February 26, 2015

ADDENDUM B

Saint James Catholic Church
Phase 1 Renovations and Additions
Kearney, Nebraska
RDG Project No. 2013.203.01, File 35.1

PROJECT NUMBER	DATE	DRAWING REFERENCED:	E01.01	SKETCH
20144450	02-24-2015	ADDENDUM NO.:	B	SDE-05

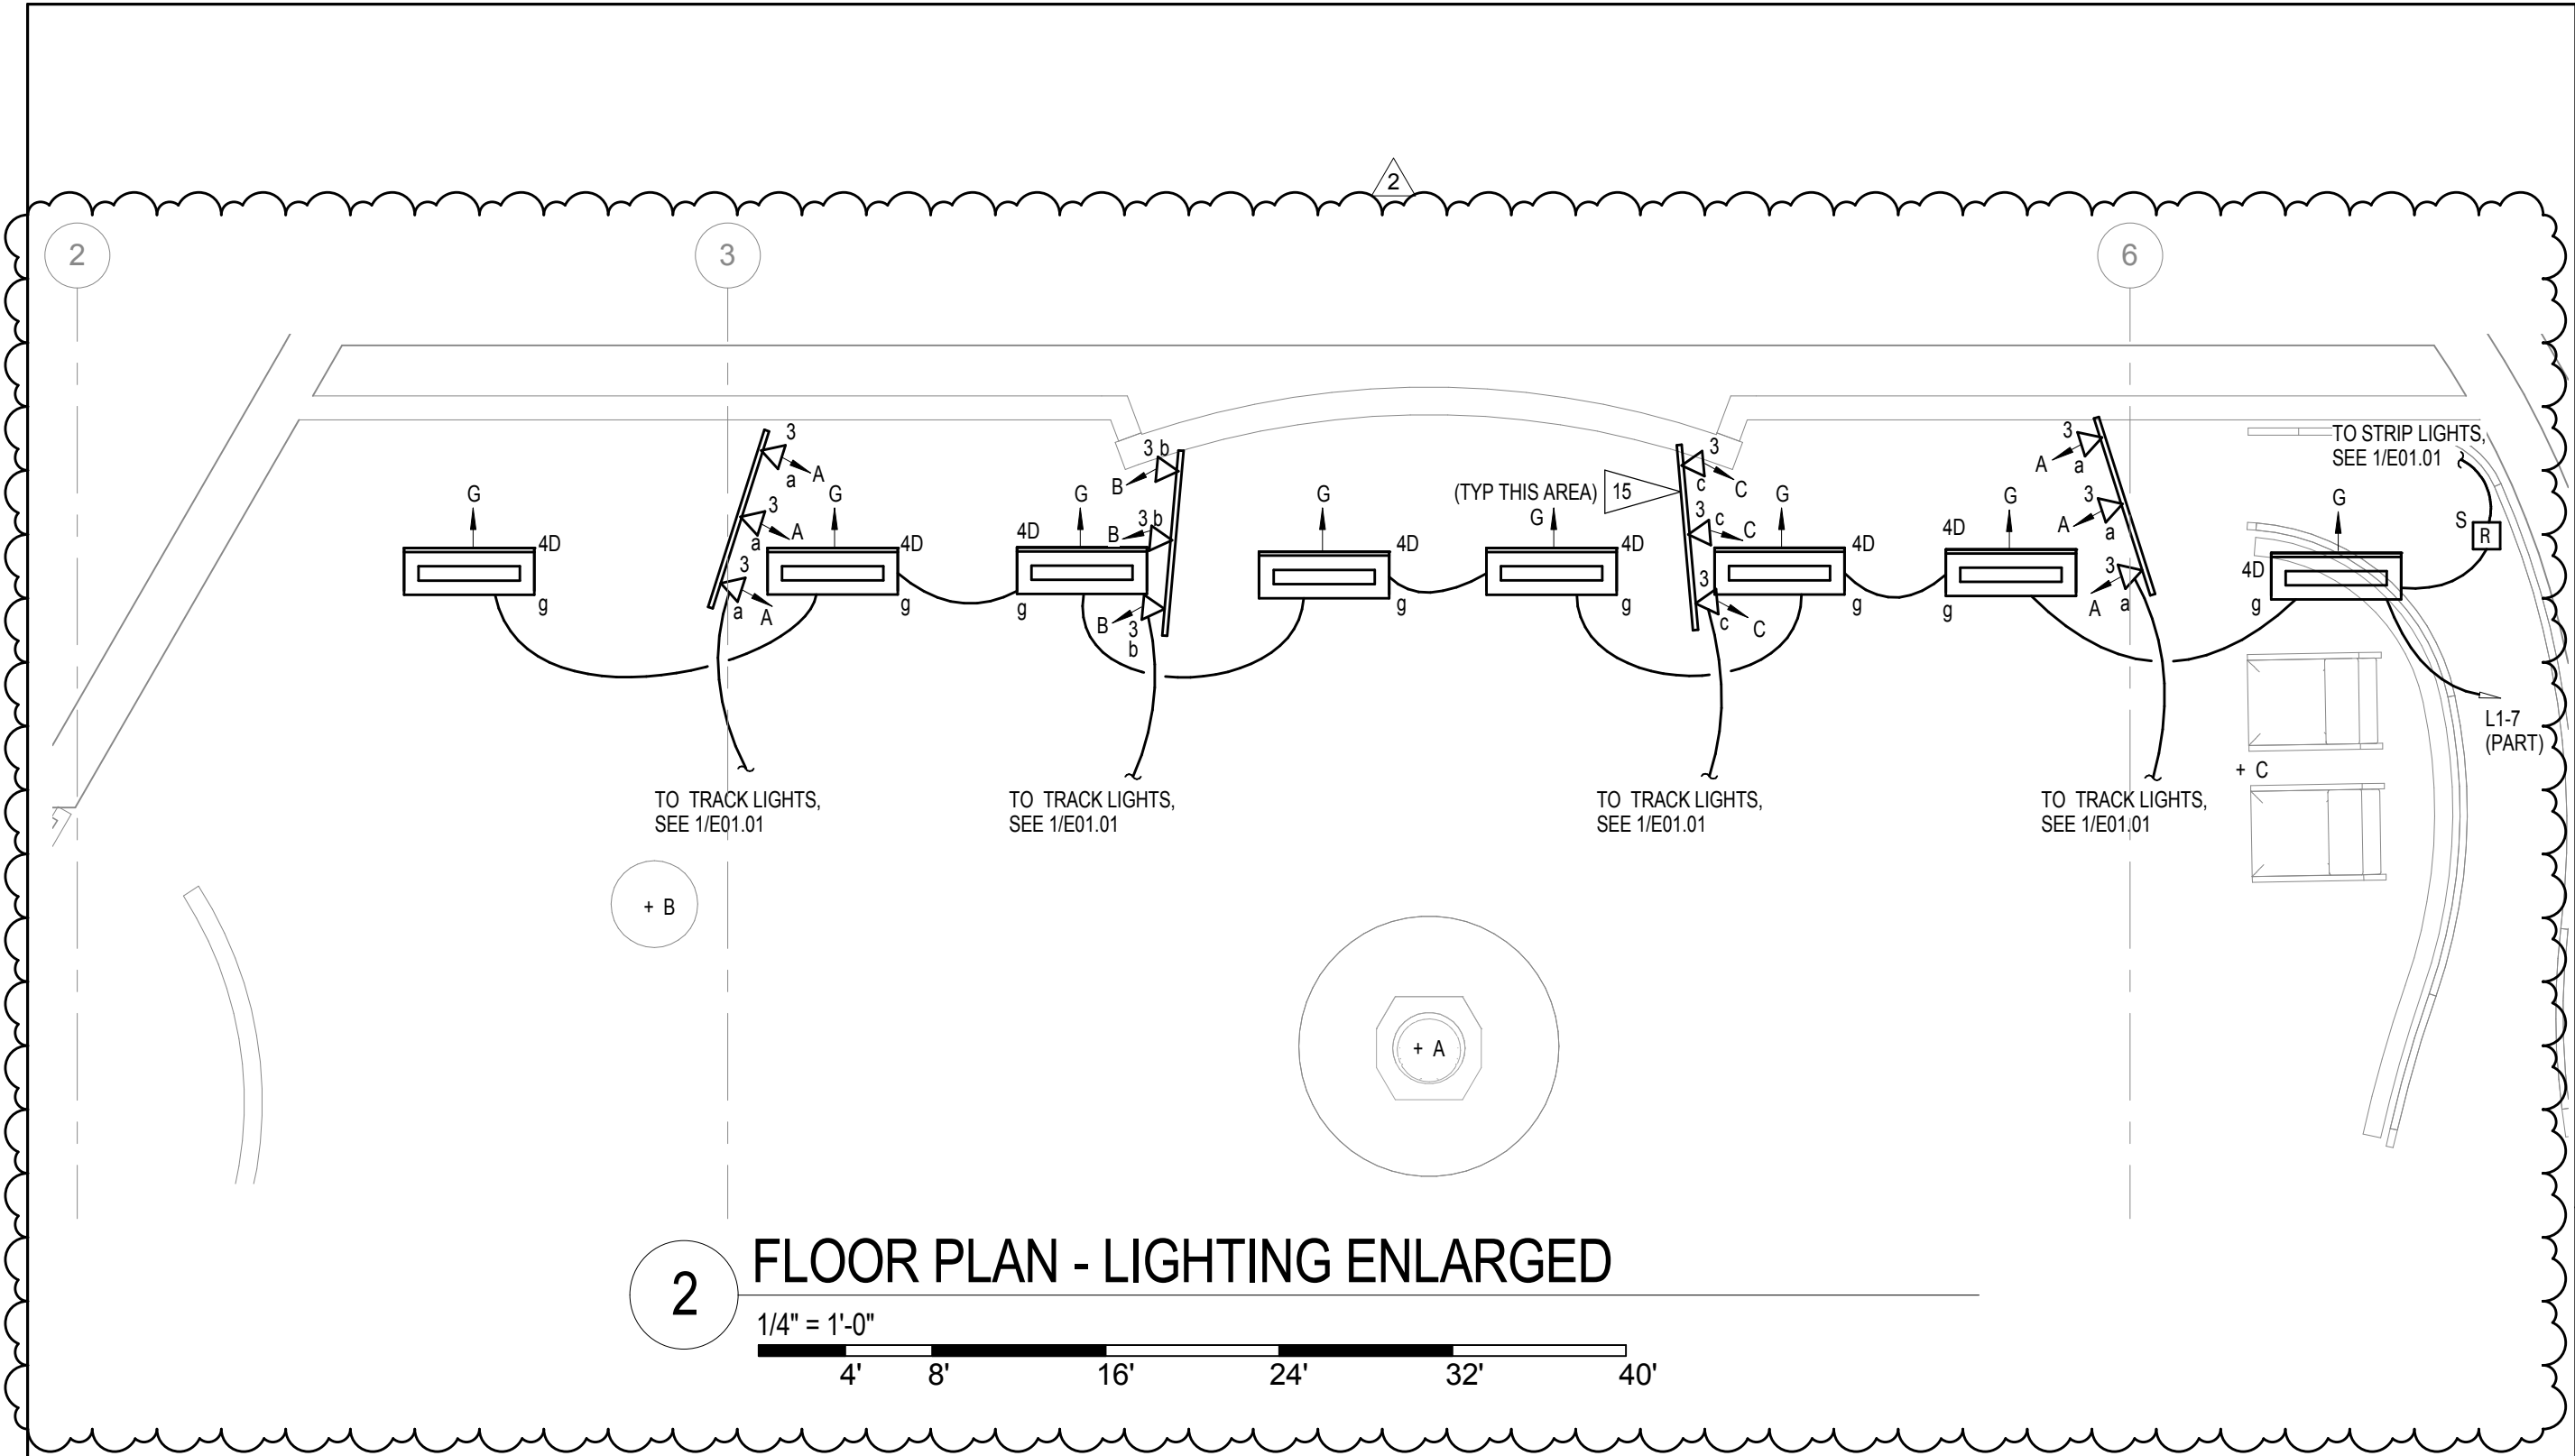
Sheet E01.01 – Floor Plan – Lighting: Revise luminaire Type 4D locations per attached Sketch Sheets SDE-04, SDE-05, and SDE-06.
